THOMAS JEFFERSON HALL
UNITED STATES MILITARY ACADEMY
WEST POINT, NEW YORK

VOLUME – IV

Option A-1
Reduce height of 2nd floor by 24" (i.e., lower 3rd floor slab 24")

Option A2 –
Replace Exposed Double-T Ceilings with Flat Slab and Gypsum Board Ceiling

A200 - A1

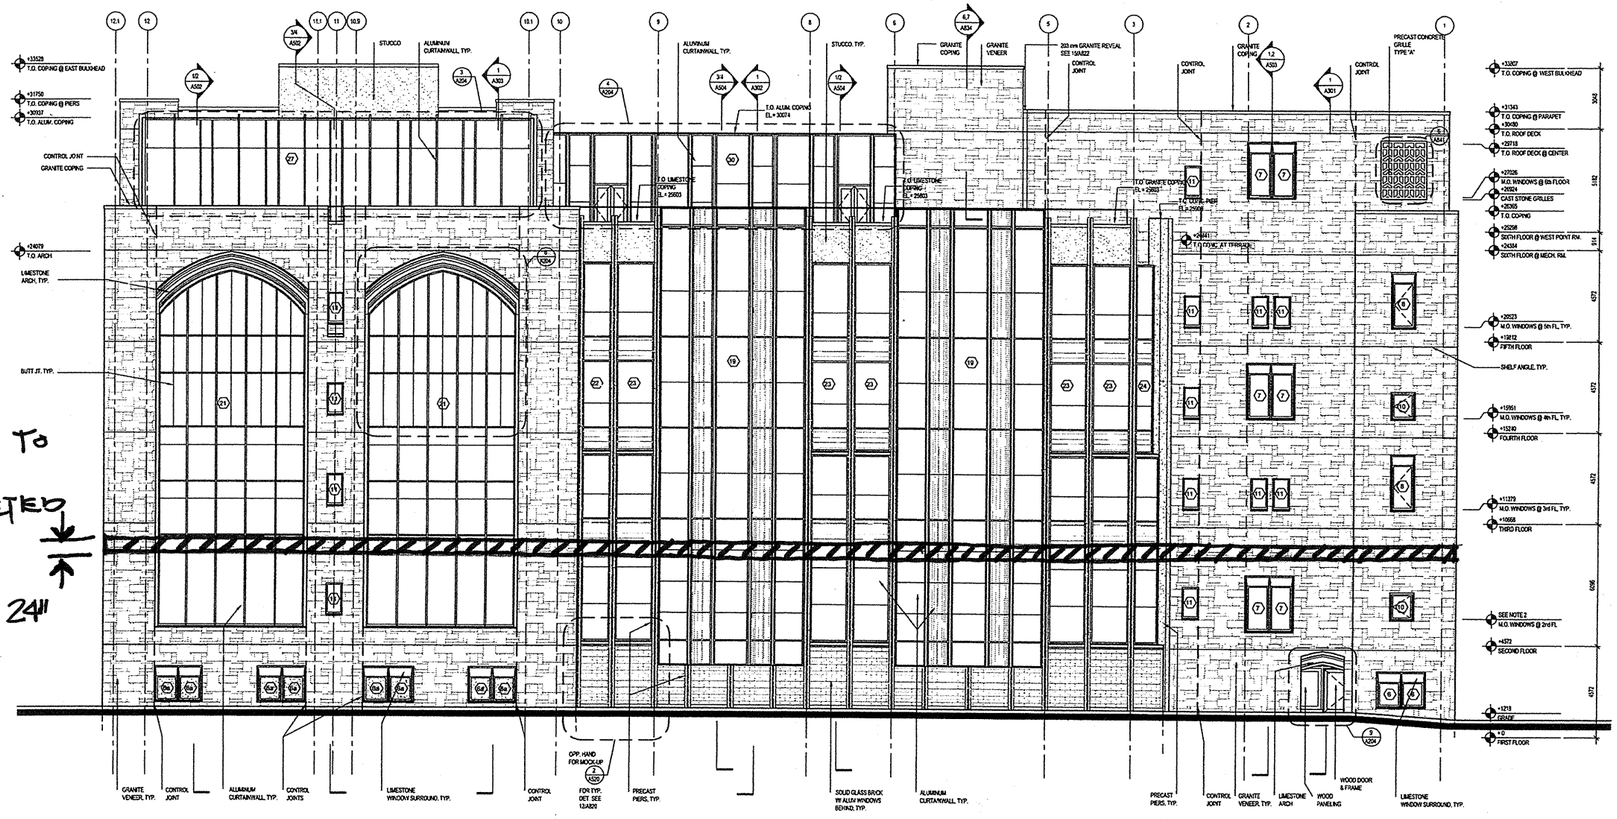
Summary Description:
This option removes 24" of building height between the 2nd and 3rd floors across the entire floor plane. No unit windows are reduced or eliminated. Exterior granite and curtain wall will be reduced. The 24" is taken from the plenum space above rooms with dropped ceilings to maintain the ceiling heights of user spaces. Rooms with no dropped ceiling are reduced in height 24"

Architectural –
- Alter exterior elevations. – See Sheets: A-200-A1, A-201-A1, A-202-A1, A-203-A1
- Reduce height of full-height interior partitions. See Sheets: A-300-A1, A-302-A1
- Reduce clearance in plenum spaces. See Sheets: A-300-A1, A-302-A1, A-402-A1
- Reduce stair travel distance.

A303 - A2

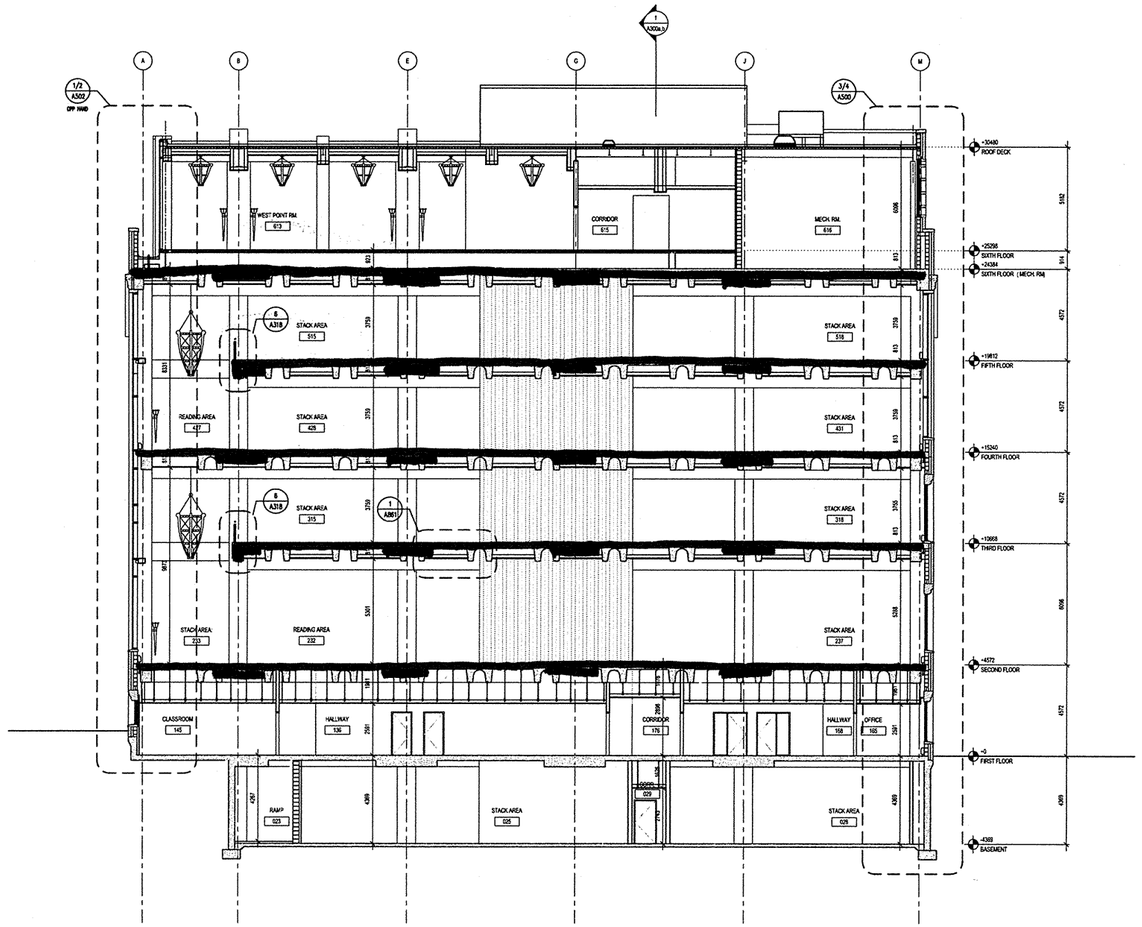
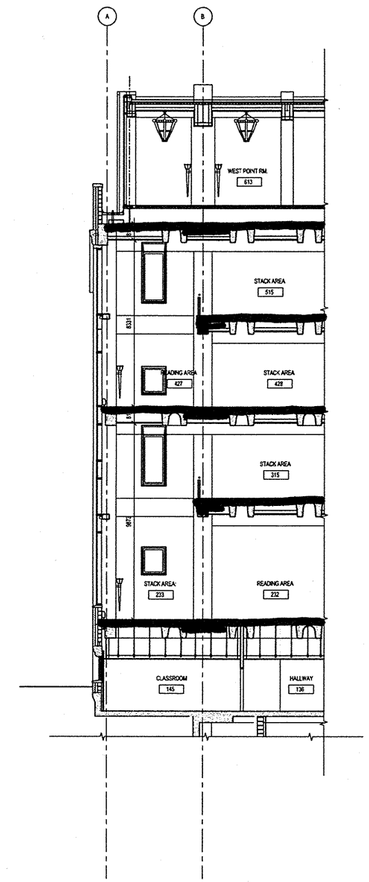
Summary Description:
This option has two elements. The first alters the structural design at the east and west wings from a double-T system to a flat slab with drop panels at the columns. The second adds a suspended gypsum board ceiling at all areas where the exposed double-T system (with OSB/tectum panels) is currently shown.

Architectural –
- Eliminate OSB/tectum panels and double-T ceiling
- Provide suspended gypsum board ceiling system. Each stack area to be provided with center soffits as now shown and with continuous perimeter soffit. See sheets: A-303-A2, A-403-A2

S104 - A2

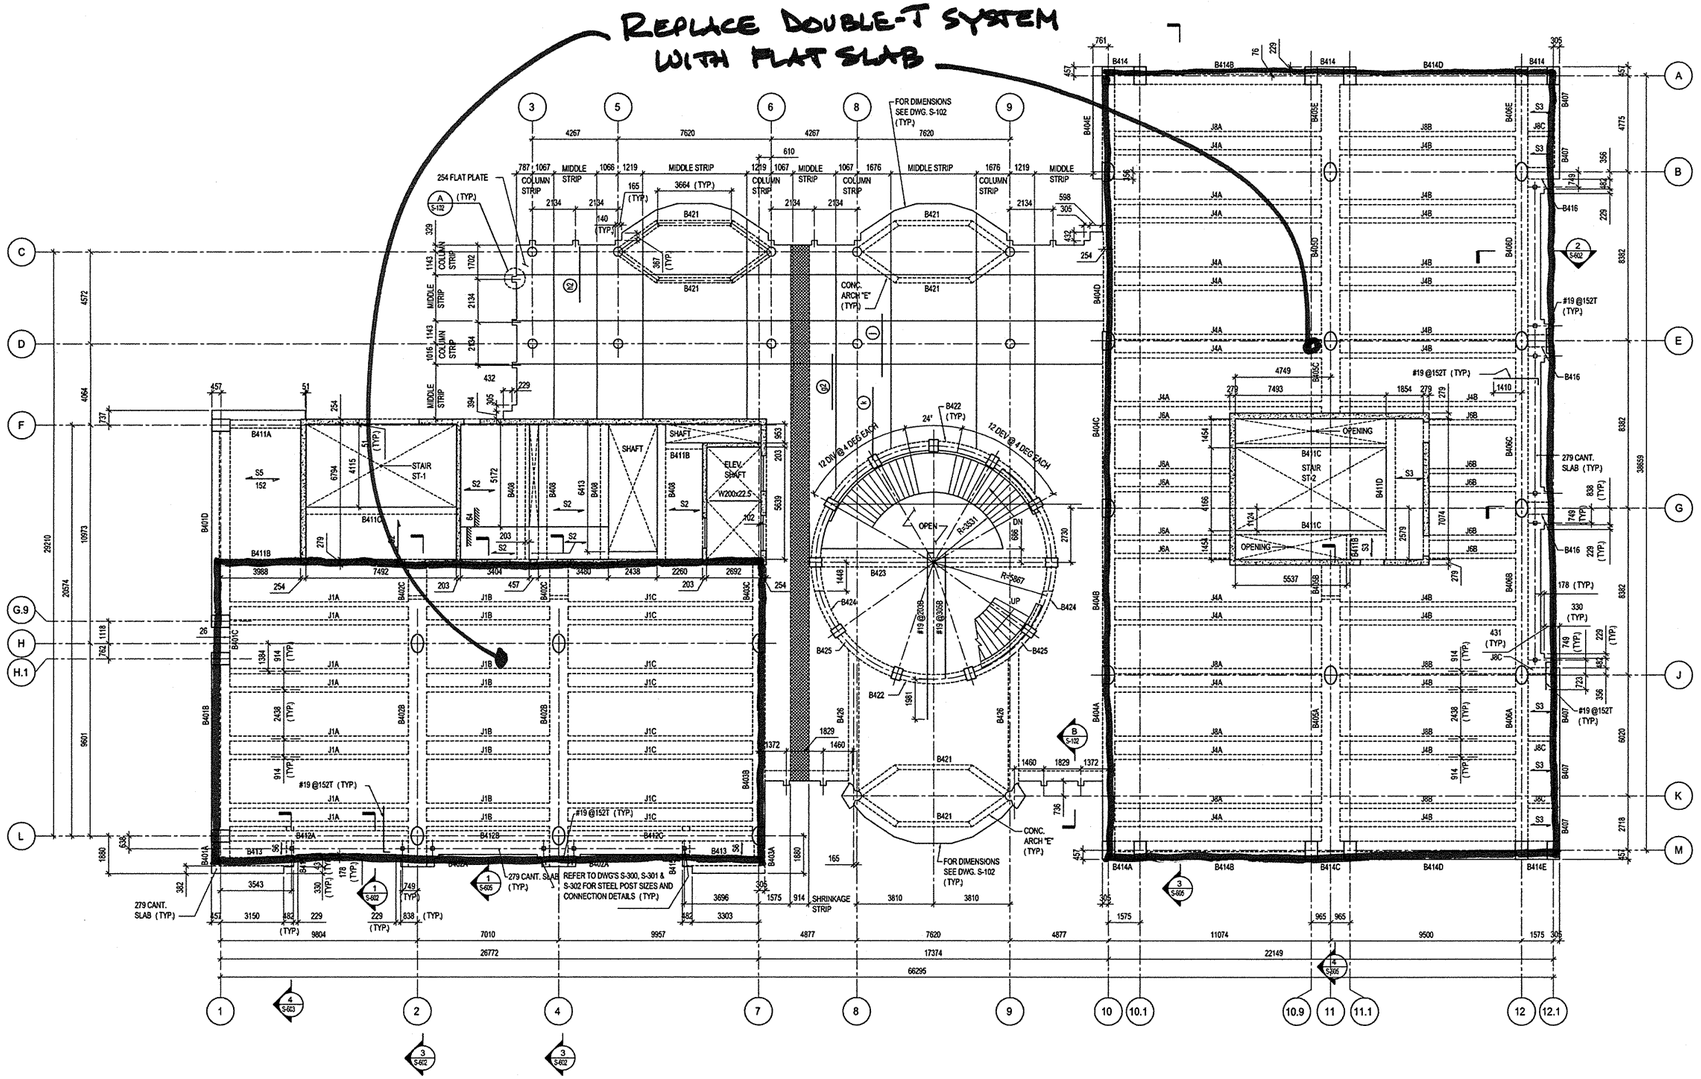
Structural –
- Provide new flat-slab structural system with drop panels at columns in the area where the Double-T design is currently shown. See Sheets: S-104-A2, SK1-A2
- Perimeter beams should remain the same as the base condition.
- Column sizes should remain the same size as the base condition with estimated column reinforcement increase of +/- 5% over base scheme.
- Footing sizes and reinforcement should increase by +/- 10% over base scheme
- Shear wall reinforcement should increase by +/- 5%.

A106 - A3

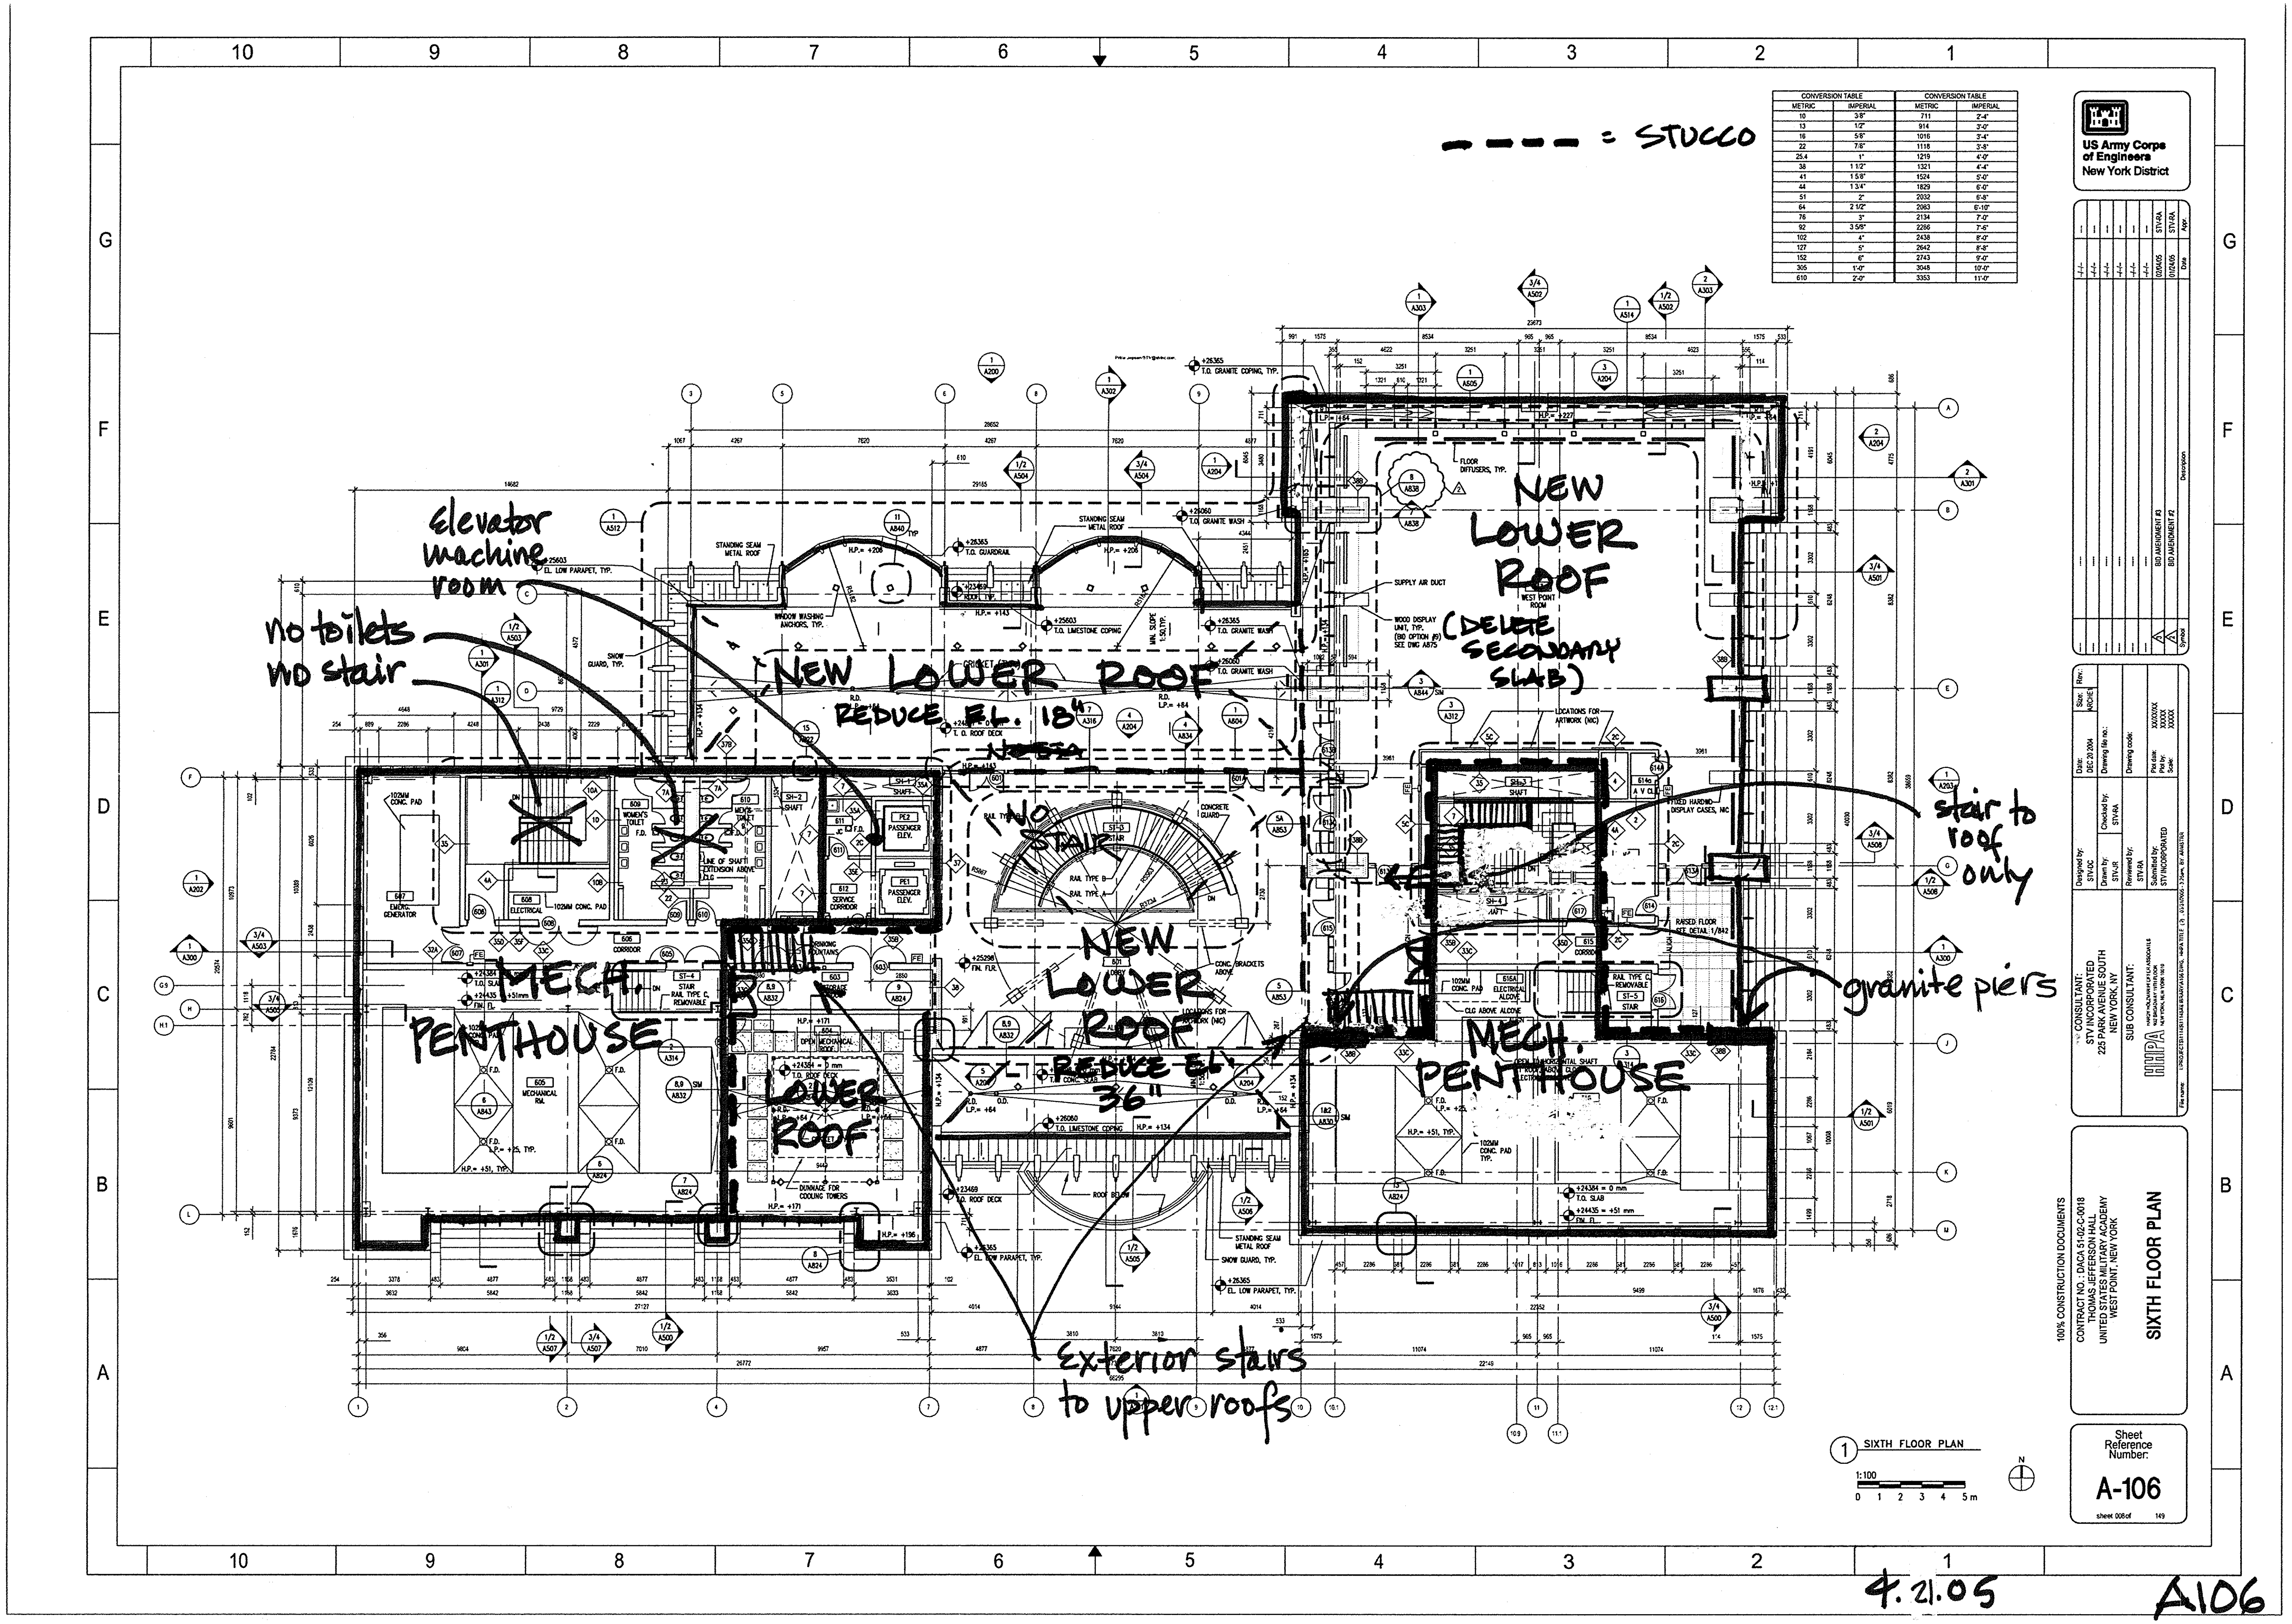
Summary Description:
This option eliminates all user spaces at the 6th floor, which will become a new lower roof with two large penthouses for mechanical equipment. Stairs and elevators serving the 6th floor will be eliminated; one stair will connect to lower roof for access to new penthouses.

Architectural –
- Eliminate User Spaces. See Sheets: A-106-A3, A-107-A3, A-300-A3, A303-A3, A405-A3
- Eliminate secondary slab and lower central portion of primary slab. See Sheets: A-106-A3, A-300-A3, A-303-A3
- Reduce plenum height at part of 5th Floor. See Sheet A-405-A3
- Alter exterior elevations. See Sheets: A-200-A3, A-201-A3, A203-A3
- Provide exterior metal stairs to roofs of new penthouses. See Sheets: A-106-A3, A-107-A3
- Eliminate elevator and stair bulkheads. See Sheets: A-106-A3, A-107-A3, A-300-A3, A303-A3
- Relocate two large mechanical units to new lower roof. See Sheets: A-106-A3, A-107-A3, A-300-A3, A303-A3
- Assume same built-up roof system throughout.
- Reduce stair travel distance 18'.
- New exterior steel stairs to connect lower and upper roofs. See Sheets: A-106-A3, A-107-A3, A-300-A3, A303-A3
